THE CLEVELAND ELECTRIC ILLUMINATING COMPANY

Perry Nuclear Power Plant
Docket Nos. 50-440; 50-441
Response to Request for
Additional Information -
Geotechnical Engineering

FIGURE 2.5-1/4

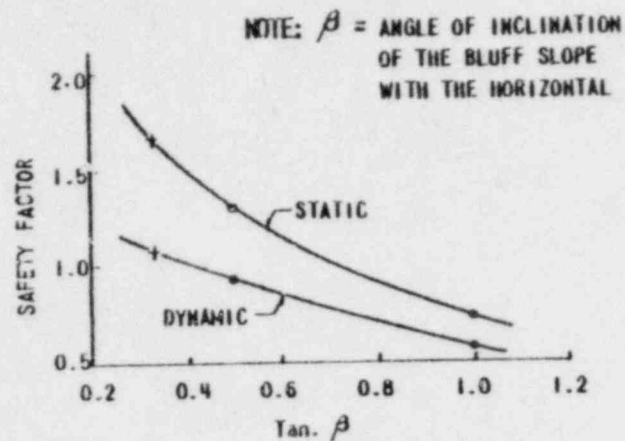
241.1 In Section 2.4.5.5.1.4, you have stated that widespread slumping
(2.4.5.5.1.4) of the upper bluff materials (which includes the lacustrine
(2.5.5.2) deposits) is caused by groundwater seepage and frost action.
(RSP) Demonstrate how this fact has been incorporated in the stability
analysis (Section 2.5.5.2) conducted to determine the amount of
bluff recession which can occur before the emergency service water
pumphouse becomes endangered. In this connection, indicate, in
Figure 2.5-174, the location of the groundwater table used in the
analysis. The staff requires that the stability of sliding
wedges, for both the static and seismic case, within the
lacustrine deposits, be investigated, utilizing methods such as
the Morgenstern-Price method of analysis.

To stabilize the bluff slope against wave action and against slumping in the zone of groundwater emergence, a flattened slope with rip-rap slope protection is required. The results of Bishop method stability analyses with bluff slope inclinations ranging from 1:1 (horizontal:vertical) to 3:1 are shown on Figure 2.5-174. It was determined in this analysis that a 3:1 slope was required for the minimum desired factors of safety. However, the presence of the rock rip-rap slope protection materials were not considered in this analysis, which would add to the overall stability of the slope.

TYPICAL SECTION
MONITORING INSTRUMENTATION
SLEEVES-1, 2, 3, 4, 11, 12 & 13
NO SCALE

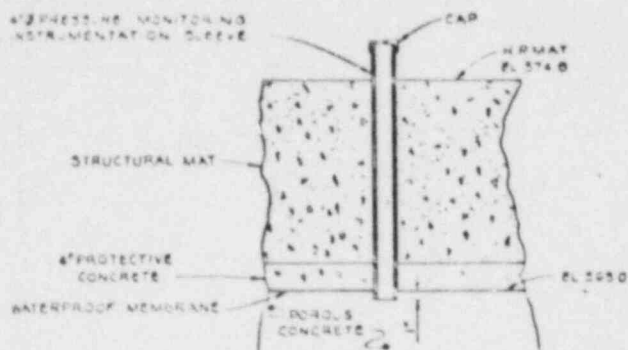
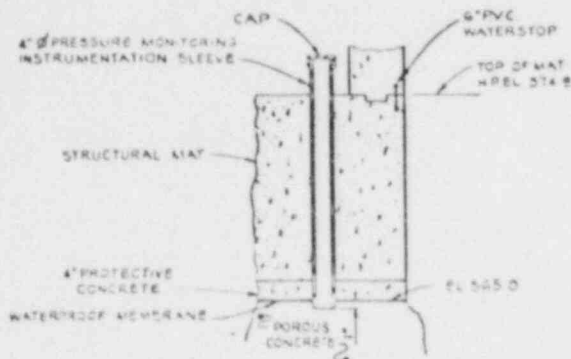
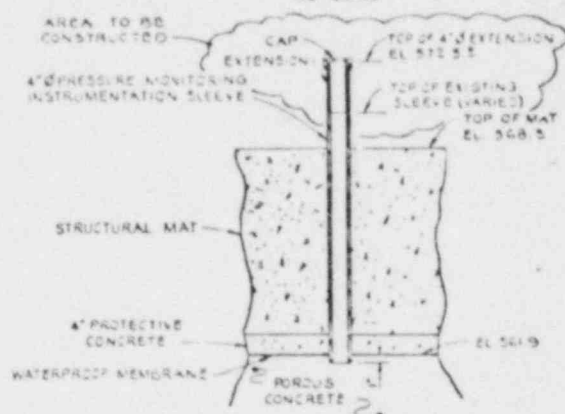
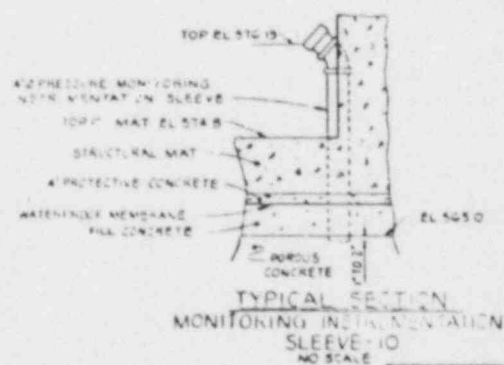
2.4.1.2 Figure 2.4-72 is purported to show piezometric devices installed (2.4.13.5.3.d) through each of the building mats of the auxiliary buildings, the control complex, the intermediate building and the radwaste building, to measure the hydrostatic uplift pressure acting under these structures. However, the tip of the only piezometer shown on the figure is founded in relatively impermeable Class B fill. Is this an error in the figure? If not, discuss the function of the piezometer in the context of measuring the hydrostatic uplift pressures acting under the structures during the life of the plant, or otherwise define its purpose.

Yes, the wrong figure was referenced. A new Figure 2.4-76 will be added to the FSAR and will be referenced in Section 2.4.13.5.3.d in lieu of Figure 2.4-72.

FIGURE 2.5-179

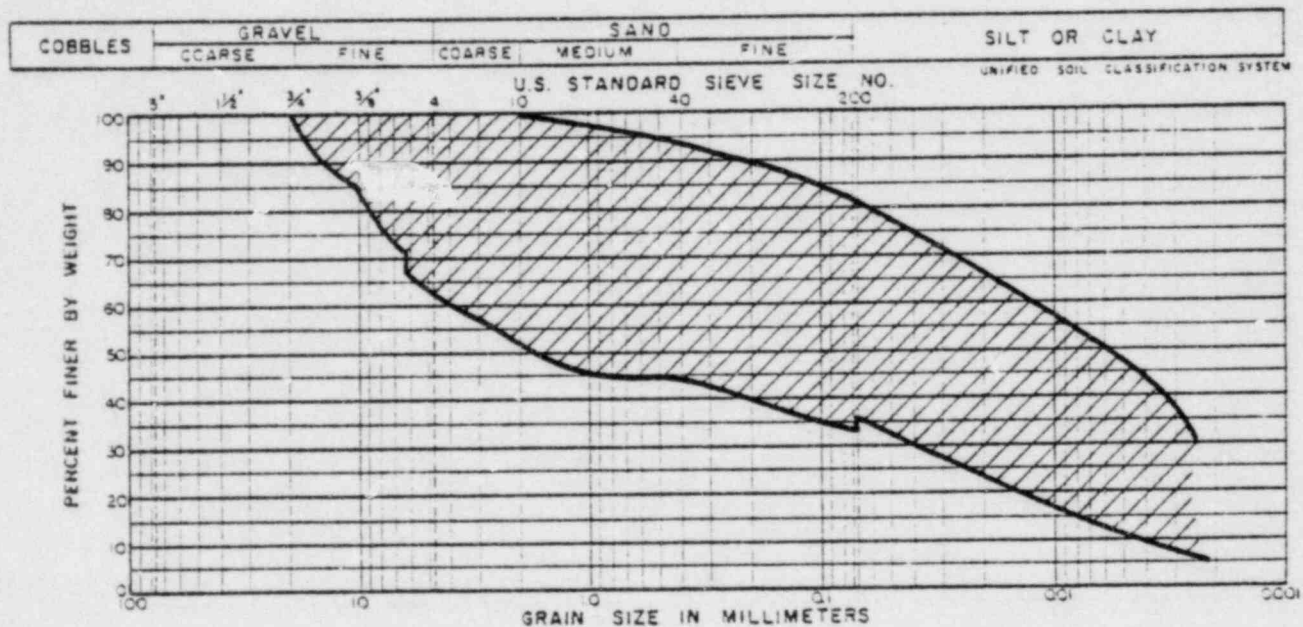
24i.3 Provide single grain size distribution plots for each of the
(2.4.13.5.5.C following materials, showing the lower and upper bounds (range)
.4.b) of the distribution.

Physical property tests conducted on representative samples of the soils at the site include natural water content, Atterberg (liquid and plastic) limits, unit weight, specific gravity and grain size distribution. The results of these tests are presented in Tables 2.5-17 through 2.5-19 and are summarized in Table 2.5-20. Grain size distribution curves are presented in Figures 2.5-94 through 2.5-96. The range of gradations of the upper till and lower till are shown in Figures 2.5-179 and 2.5-180.

Figure 2.5-184

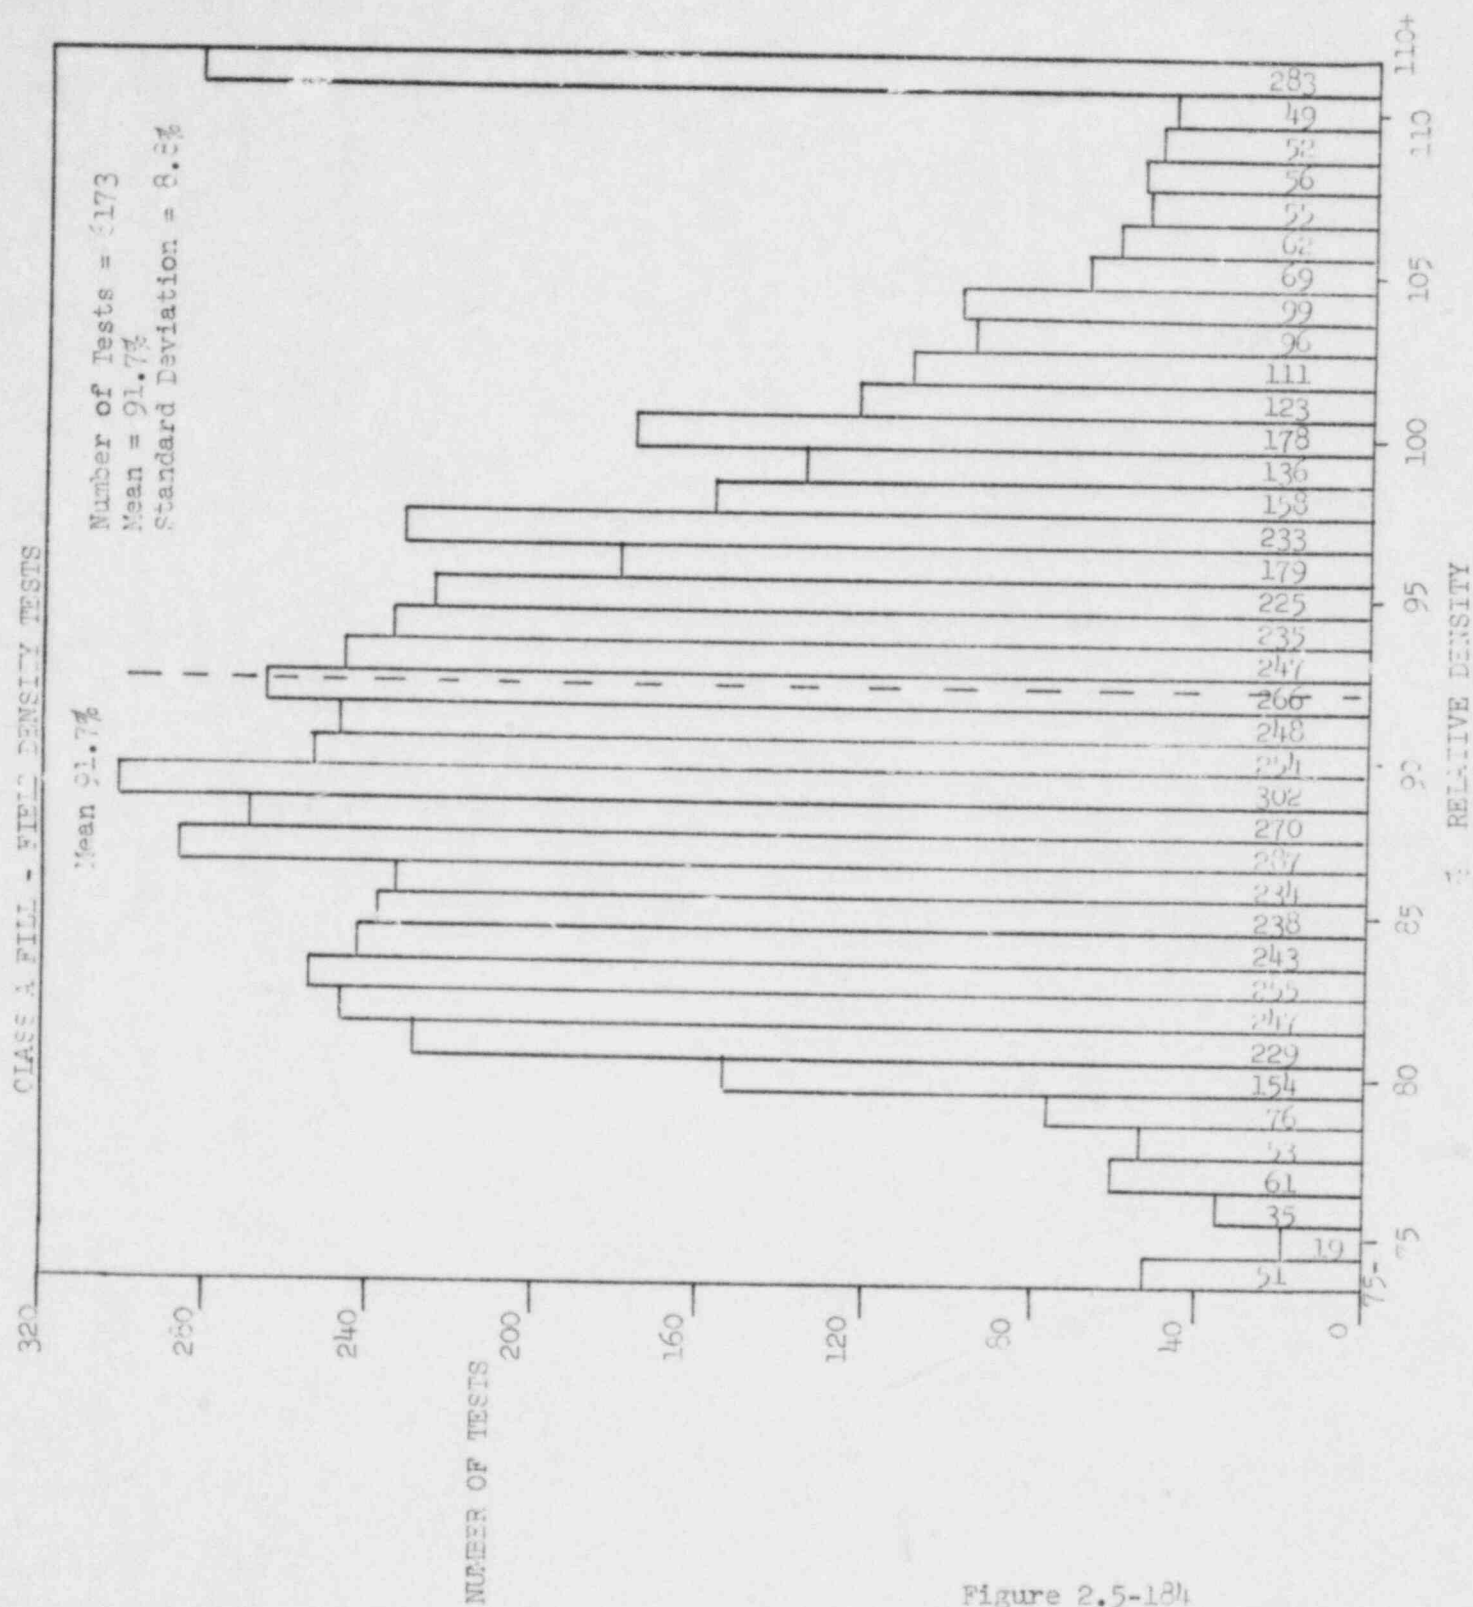
241.5
(2.5.4.5.2) Provide a summary of field density and moisture tests obtained for quality control during construction of Class A and Class B fill. The results may be presented as a statistical distribution plot showing low, high and average values. This would help the staff to conclude that suitable compaction has been obtained.

areas outside of building lines. Minimum and maximum density tests were performed for each 4,500 cubic yards of fill placed, and in-place density and grain size distribution tests for each 150 cubic yards or once per lift, whichever was more frequent. However, in confined areas, where the volume of each lift was less than 50 cubic yards, in-place density tests were performed once every third lift or every 50 cubic yards, whichever was more frequent. Through the end of July, 1981, approximately 437,000 cubic yards of safety-related Class A fill have been placed, and approximately 6,170 in-place density tests and grain size distribution tests have been performed. The gradation range of the Class A fill which has been placed is shown in Figures 2.5-181 and 2.5-182. A summary of field density tests obtained for quality control during the placement of Class A fill is shown in Figure 2.5-184.

EARTH PRESSURE DIAGRAMS FOR
RIGID SUBSURFACE WALLS

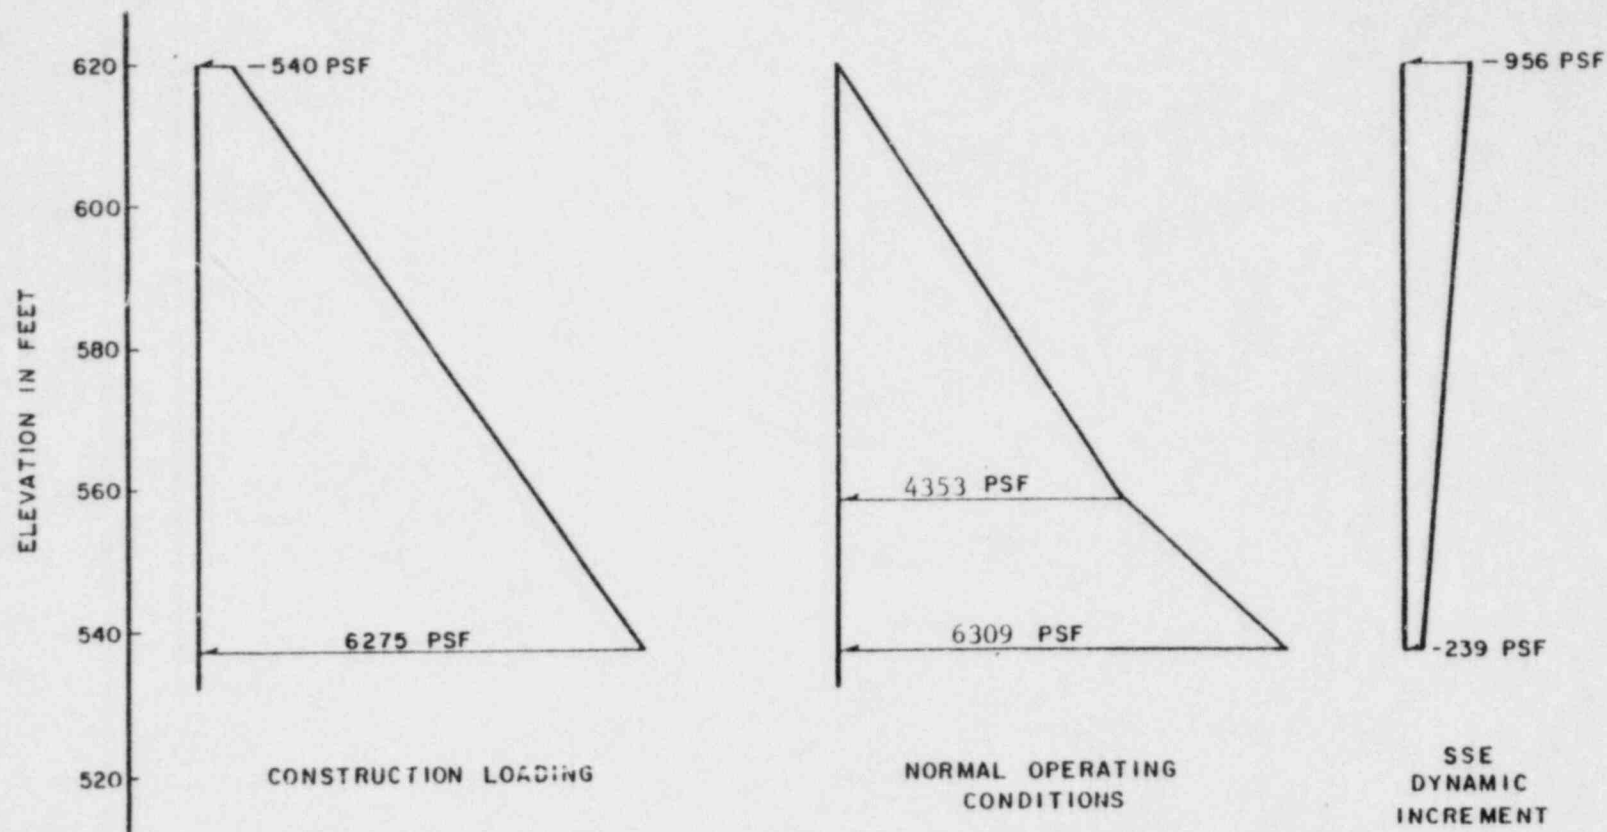
241.6 In Section 2.5.4.10.4.1, justify the use of 0.54 as the value of
(2.5.4.10.4.1) the coefficient of earth pressure at rest. Provide a plot of
maximum earth pressure vs. depth used to design subsurface walls
under static and dynamic loads. Include and distinguish the added
lateral pressures due to compaction of the backfill and the effect
of compaction equipment.

Plots of the maximum earth pressure vs. depth used to design rigid subsurface walls for static and dynamic loads are provided in Figures 2.5-176 and 2.5-177. Diagrams in Figure 2.5-176 are applicable to all Category I structures, except for the emergency service water pumphouse which is shown in Figure 2.5-177. Each structure was analyzed to determine the maximum design stresses resulting from the following earth pressure loading conditions:

FIGURE 2.5-173a

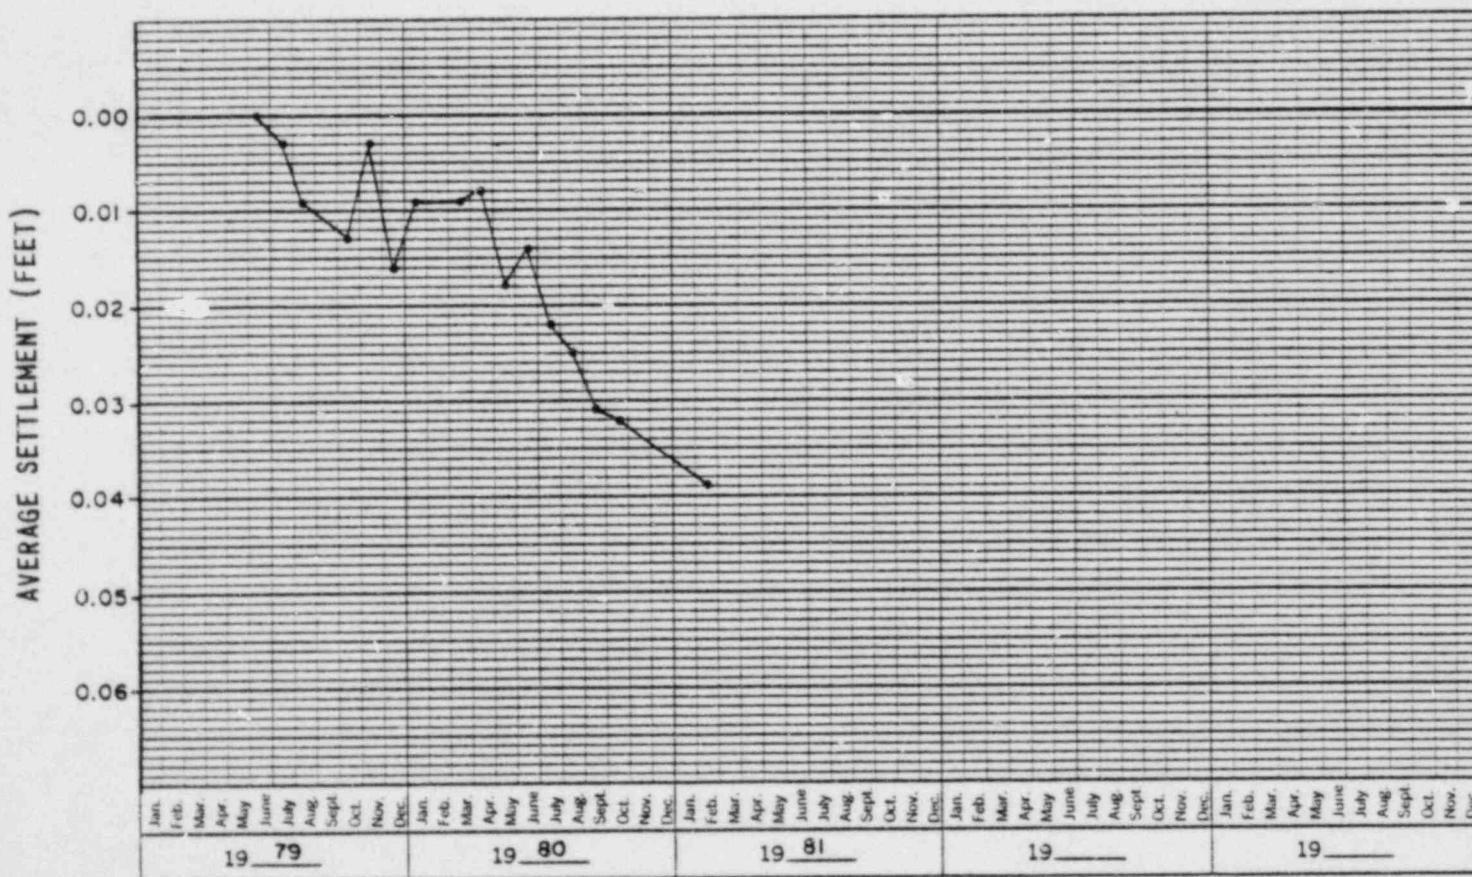
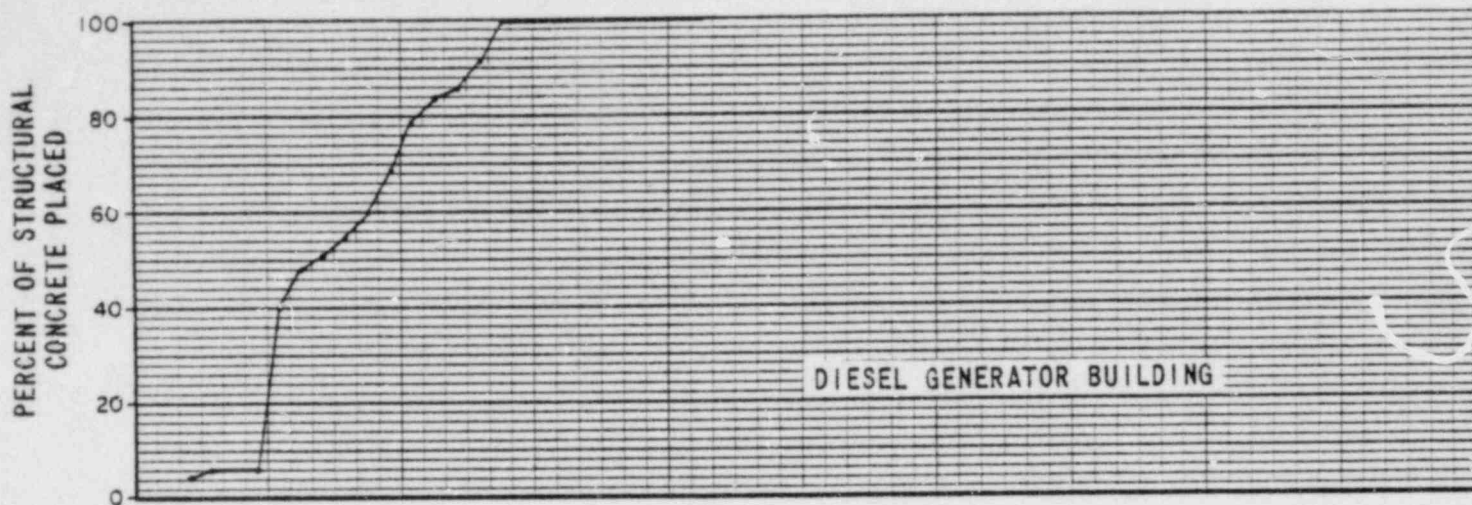
- 241.7 Provide construction details of the settlement monitoring points.
- (2.5.4.13.4) Update the time vs. settlement plots for all Category 1 structures where settlements are being monitored. Discuss any deviations from anticipated settlements assumed in the analysis and design of these structures and components. Evaluate all deviations for their impact on the design and construction of these structures and components.

Six settlement monitoring points were established on the diesel generator building in June 1979, shortly after the structural mat was cast. Seven new points were established at a slightly higher elevation in June 1980, and the old points were subsequently abandoned. The monitoring results, shown on Figure 2.5-173a, indicate that the average settlement through February 1981 has been slightly less than one-half inch.
